PREVOST

**WARRANTY
BULLETIN**

Wb99-15

| SUBJECT: PROTECTION OF LAMPS LOCATED IN THE DRIVER'S SECTION | |

Figure 1: Typical location of the lamp, in the driver's section.

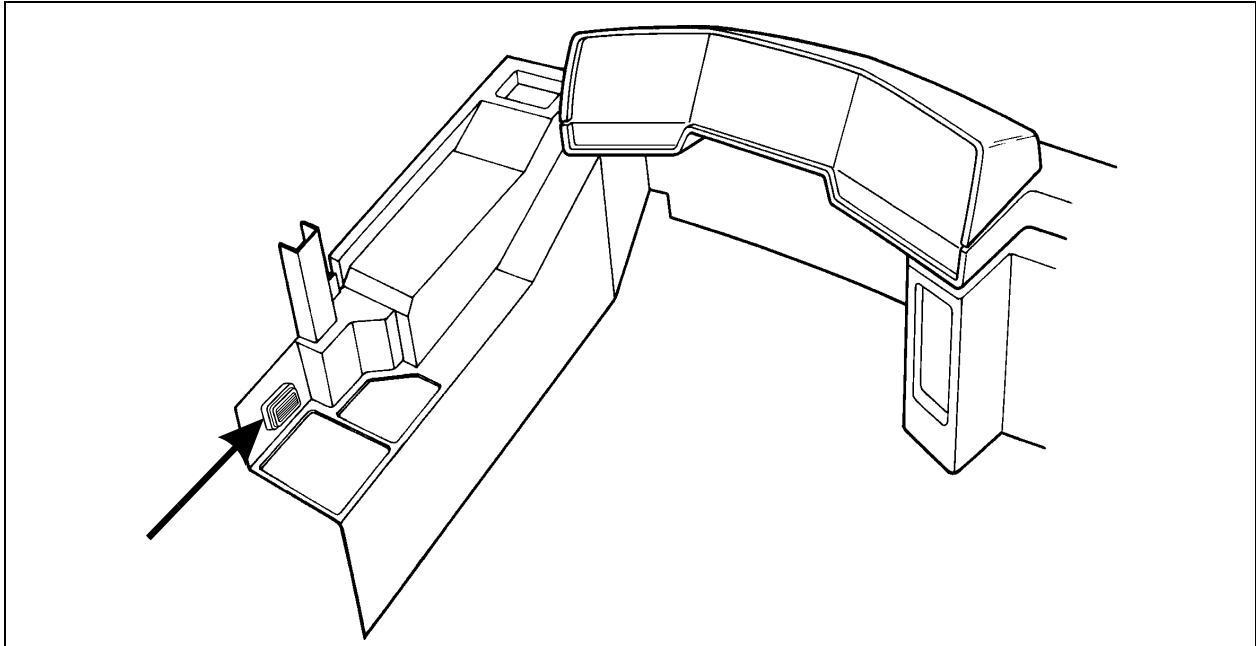
Addition of a fuse to the lamp located above the bin in the driver's section.

1. Locate the lamp (figure 1).
2. Open the front service compartment.
3. Identify and cut lamp wire #83.
4. Cut fuseholder wire, skin ends. Select the proper spring for #560893 fuse. Remove remaining springs, insert #560893 fuse and reassemble.
5. Twist wires and cover with a shrinkable tubing. Heat.
